**MODIFICATION REQUEST:
Koondrook-Perricoota Forest Flood
Enhancement Project
(MP 09_0098 MOD 1)**

***Discharges to the Barbers Creek system and
Thule Creek and construction of a new Sandy
Bridge***

Environmental Assessment Report
Section 75W of the
Environmental Planning and Assessment Act 1979

June 2017

Figure 2 Outflow rates (Source: Koondrook-Perricoota Forest Flood Enhancement Works: Section 75W modification Environmental Assessment (Forestry Corporation, February 2017))

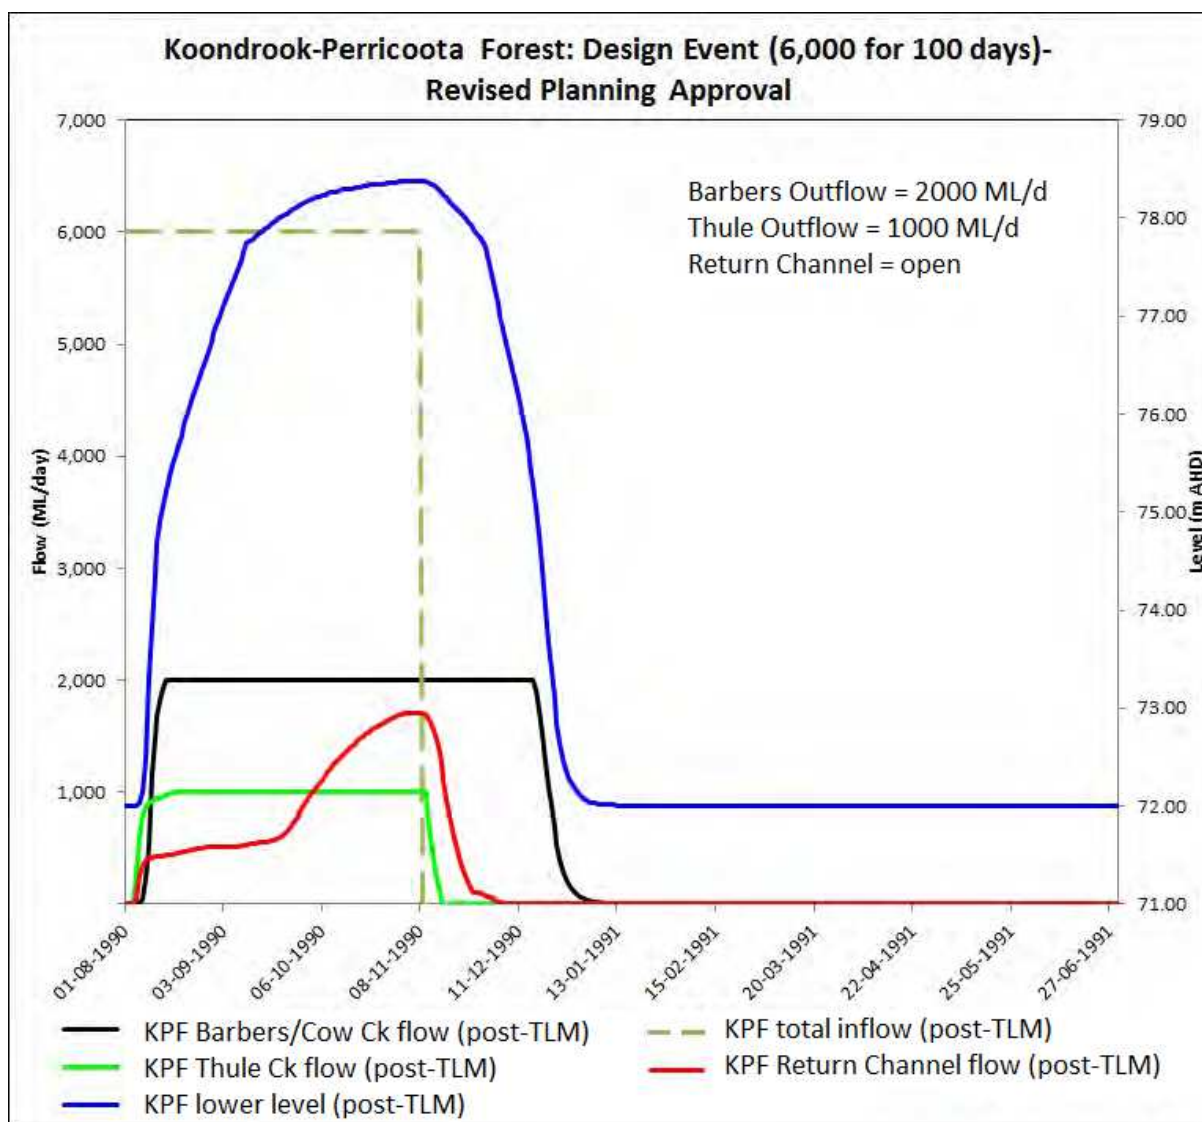
In summary, the Proponent states that the duration of discharges to downstream waterways in a managed flood event under the modified proposal would be reduced to 145 days, from 250 days under the approved project. The currently-approved long duration of events is a major concern of the Wakool River Association, and the Department supports this reduction as a way to reduce effects on affected landholders.

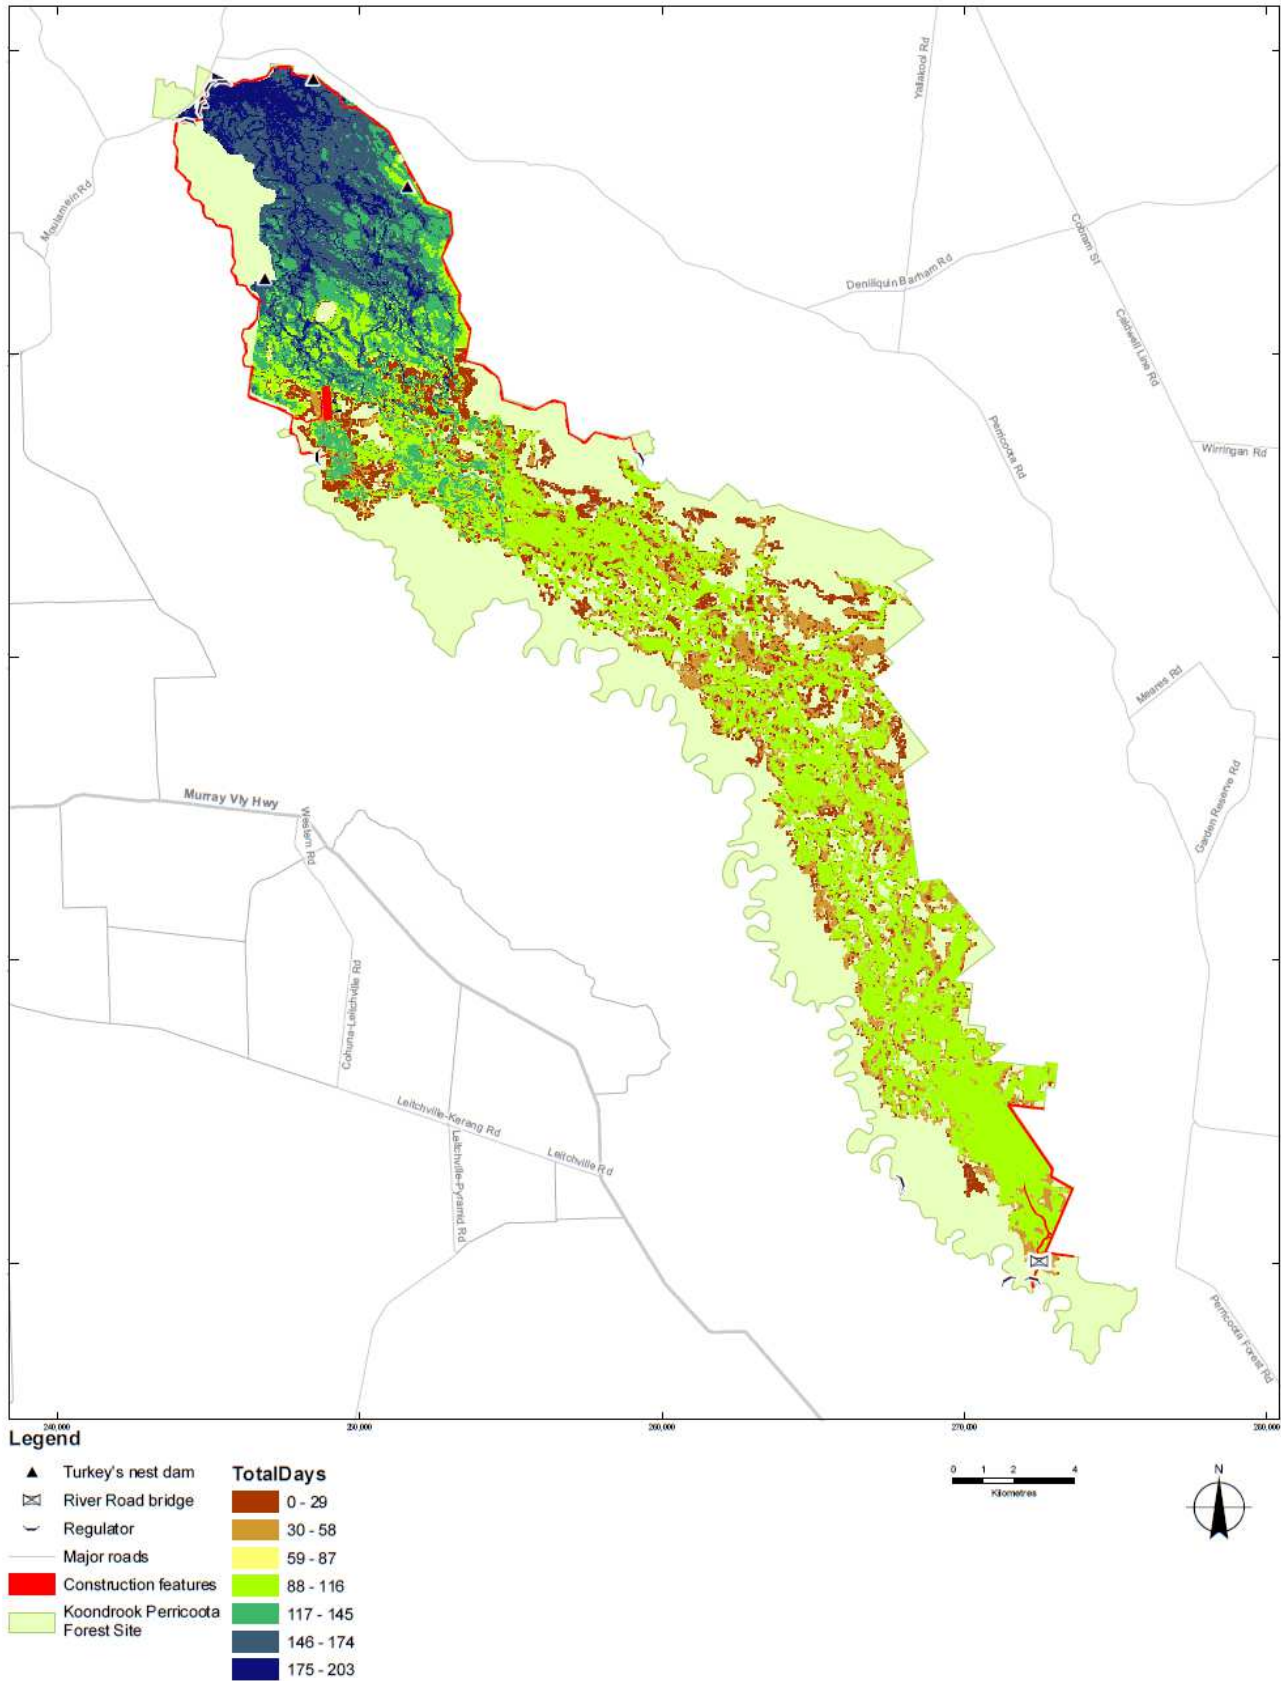
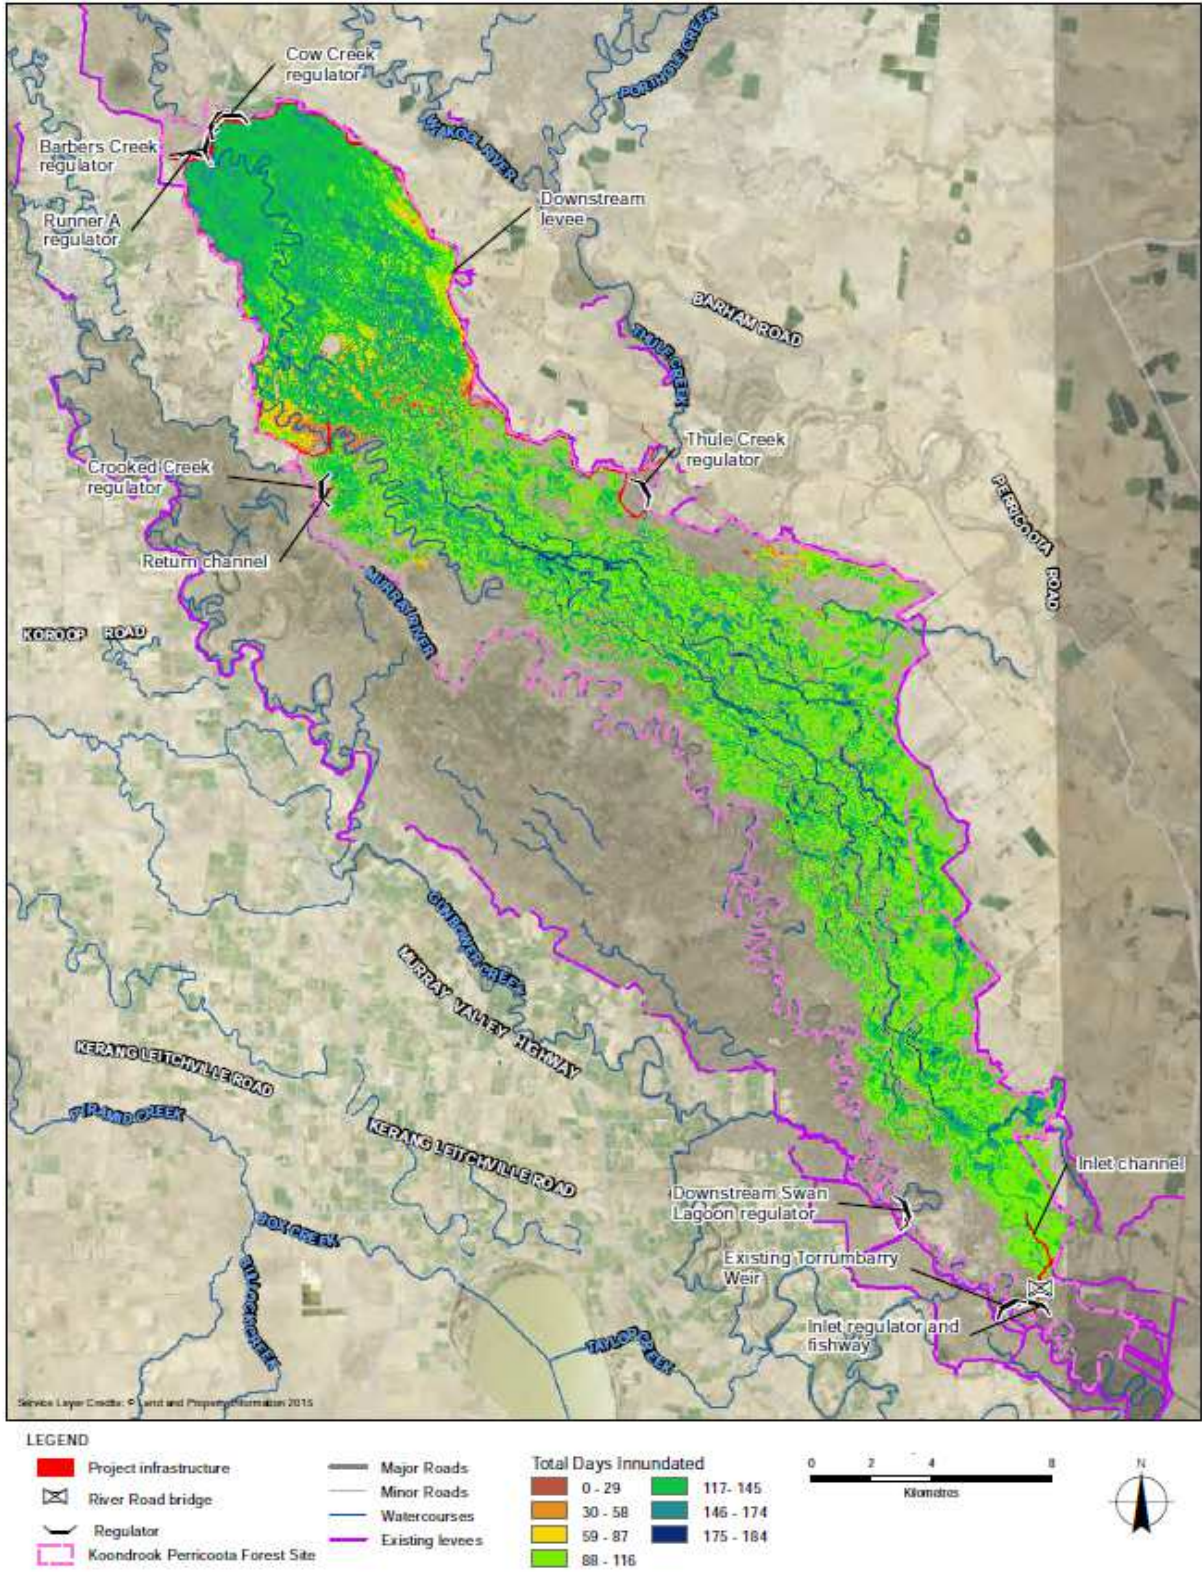
The Department considers that the changes in flow and inundation would have a positive effect on achieving the objectives of the project to support flood dependent species and ecological communities. This effect includes inundating an additional 3,307 hectares of River Red Gum communities, and other flood-tolerant species within their tolerance ranges.
